| NO. Δ Add Special Note REVISION BY DATE Wapl G-14-85 | DATE 3-27-85 DESIGNED H.K.M. DATE 3-26-85 CHECKED G.A.L. DATE 3-28-85 SCALE 1/8"=50' CONTRACT NO. DNT-114 SHEET R19A OF |
| TEXAS TURNPIKE AUTHORITY DALLAS NORTH TOLLWAY SAKOWITZ VILLAGE PARKING LOT RENOVATIONS | |

PARKING ISLAND PLAN LAYOUT
Not to Scale

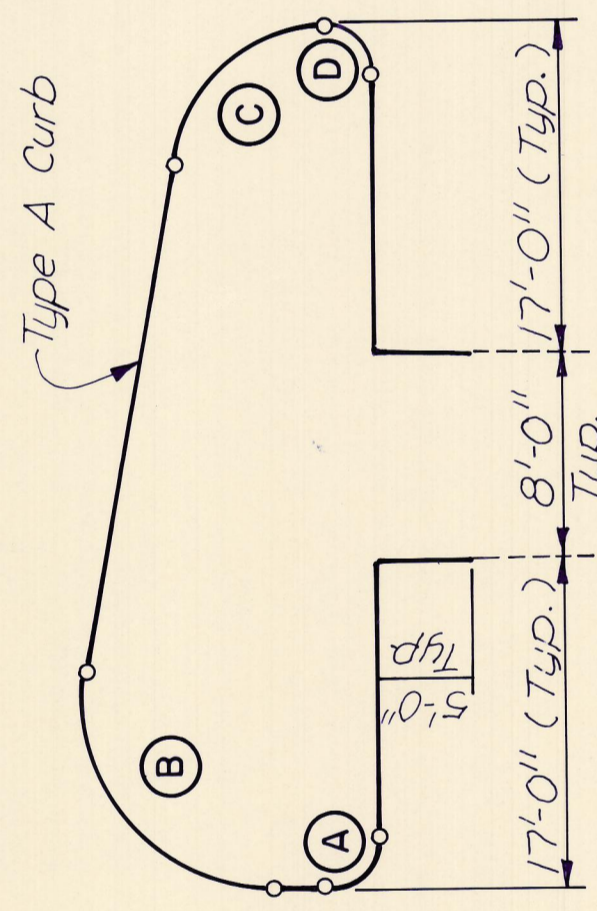
SPECIAL NOTE Δ
Existing Handicap Ramps shall be removed and replaced with 4" concrete sidewalk.
